City of Alameda, California

**CONSTRUCTION DOCUMENTS FOR
MAINTENANCE SERVICE CENTER ROOF REPLACEMENT
No. P.W. 09-16-18
ADDENDUM NO. 1**

CONSTRUCTION DOCUMENTS FOR
MAINTENANCE SERVICE CENTER ROOF REPLACEMENT
No. P.W. 09-16-18

ADDENDUM NO. 1

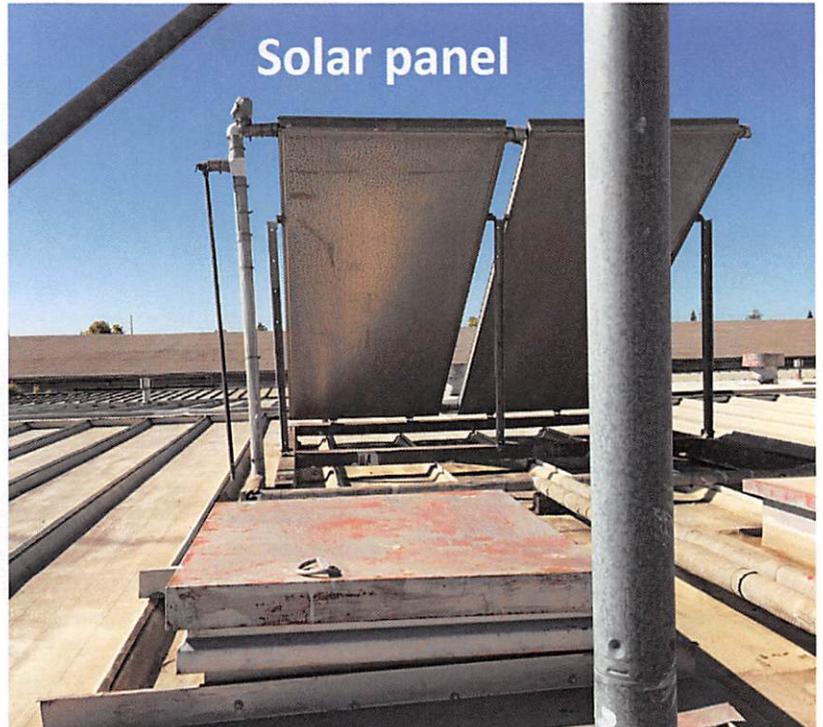
2. Abandoned equipment as noted in attached photo shall be removed and legally disposed.
3. HVAC units do not have to be raised.
4. At perimeter walls, remove existing wall panels (except at lower roof to wall intersection) mechanically install ½" plywood. IB membrane to be adhered with IB Vertibond adhesive.

These two abandoned equipment shall be removed and legally disposed as part of the project scope of work.
